CASE#: C15-2015-0162
 Address: 2801 SPIRIT OF TEXAS DRIVE

CITY OF AUSTIN
APPLICATION TO BOARD OF ADJUSTMENT
GENERAL VARIANCE/PARKING VARIANCE

Re: REQUEST FOR VARIANCE to
LDC 25-2-814
Ground Transportation Fueling Facility
Austin Bergstrom International Airport

Site Plan Review - Lynda Courtney - 512-974-2810

RENDERED SITE PLAN

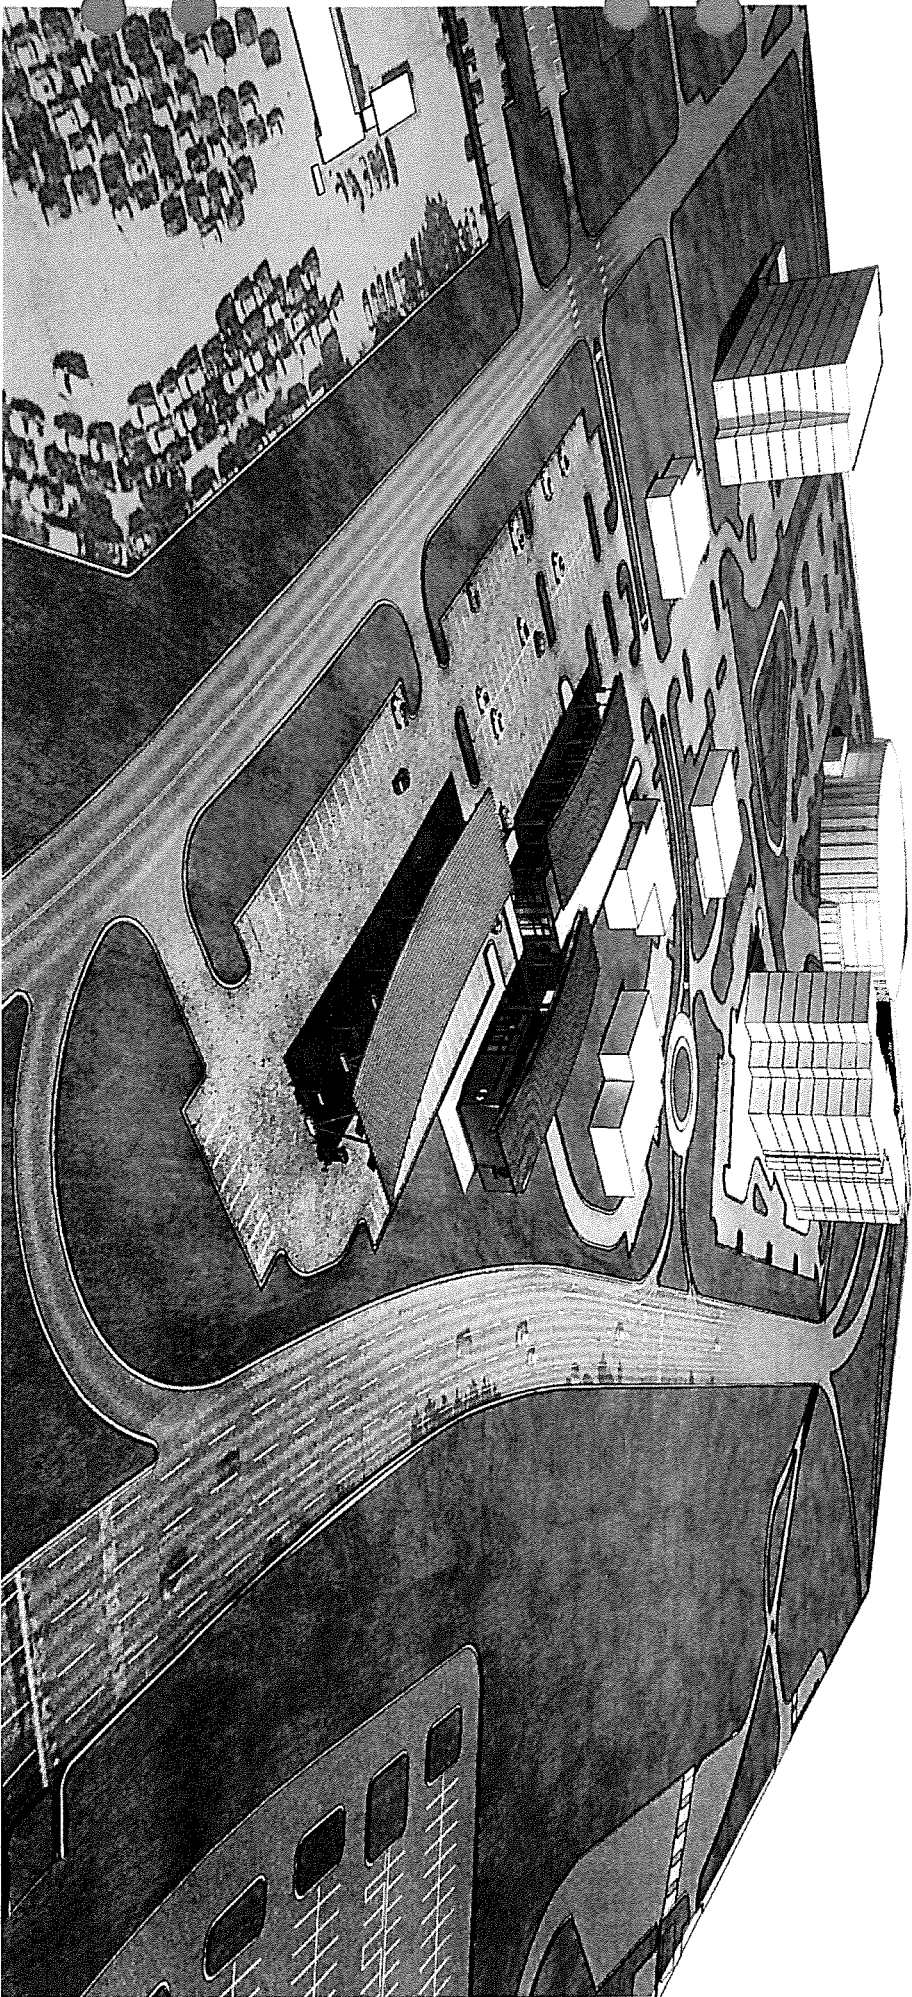
SP 4. Please note how many gas pumps are intended to be constructed with this plan, and in what configuration. Please show the type of dispenser and number of intended pumps.

★ SP 5. Under LDC 25-2-814, Service Station Use, limits the number of dispensers to 16 and the number of queue lanes to 8. Please adjust your design to comply with this.

SP 6. The canopies as shown do not provide shade protection for the primary entry of the convenience store, or for one of the entries of the restroom facilities of Building B. Please move the entire canopy to the north (?) or expand the canopies to provide a shade awning/canopy of at least 5' in width over the entry door of the convenience store and over the restroom entry.

SP 7. The north arrow shown on the site plan does not line up with the direction of the north arrow of the site location map on the cover sheet. Please align both the directions to be correct.
